A20 Modification Regarding Remote

This solves problem with misunderstanding remote control commands

Picture of top side, front board

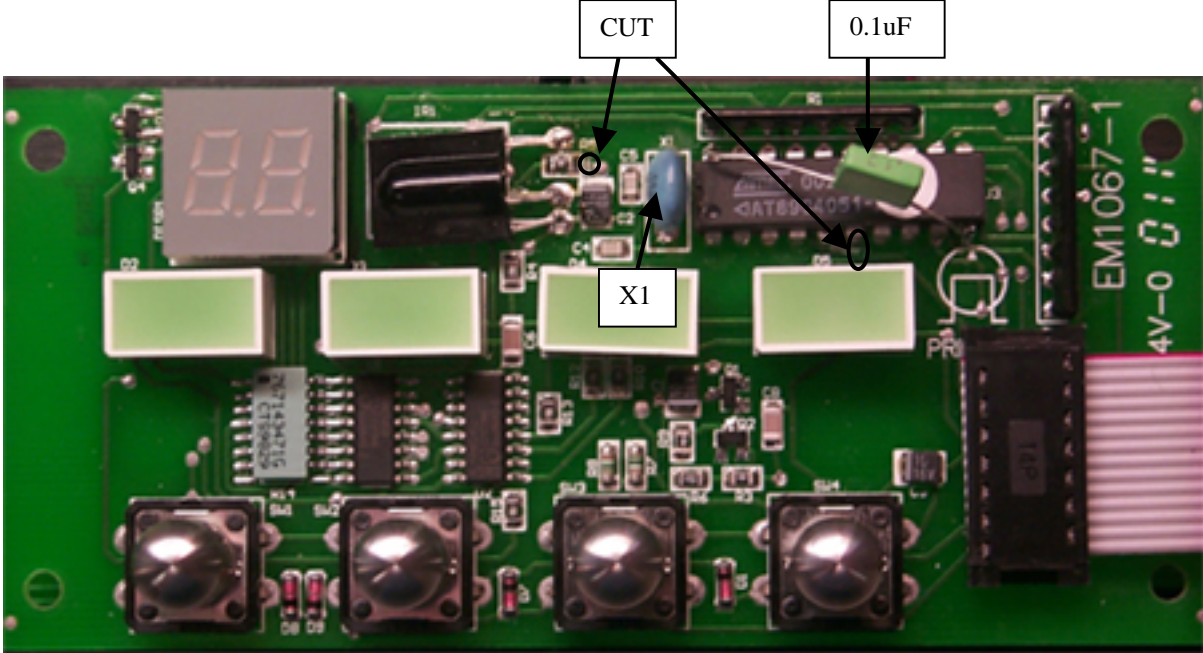
Try first with changing the ceramic oscillator (crystal) X1, this usually

Solves the problem. The crystal is a Murata 12Mhz Ceramic Oscillator (CSA12.00MHZ).

Cut the signal trace from the Ir-receiver, between R5 and the via-hole.

(Not between R5 and the receiver). Cut it also in the other end, pin 6 Processor.

Picture of bottom side, front board.

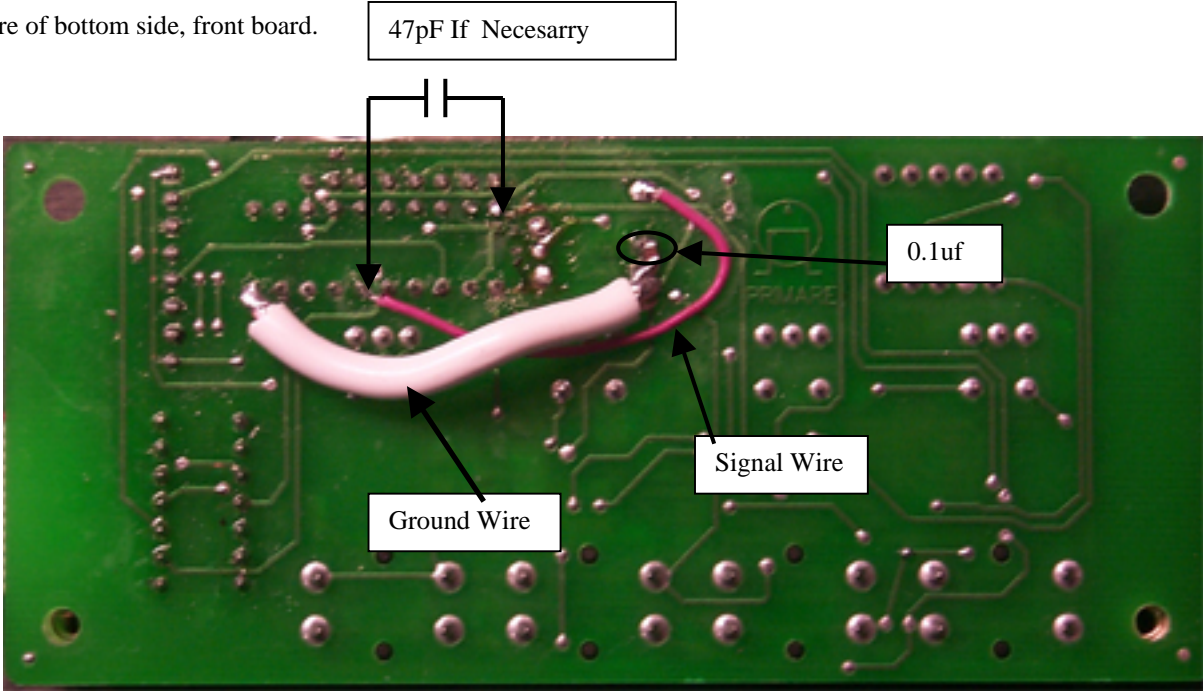
Solder a wire (use 0.75") between the output of the Ir-reciver and pin 6 processor.

Solder a wire (use 0.75") between the ground of the Ir-reciver and pin 10 processor.

Solder a 0.1uF capacitor between the 2 bottom pins Ir-reciver.

Solder a 0.1uF capacitor between pin 10 and 20 processor.

Solder a 47pF capacitor between pin 6 and pin 20 proc. This lowers the sensitivity of the remote control but if nothing else works.....
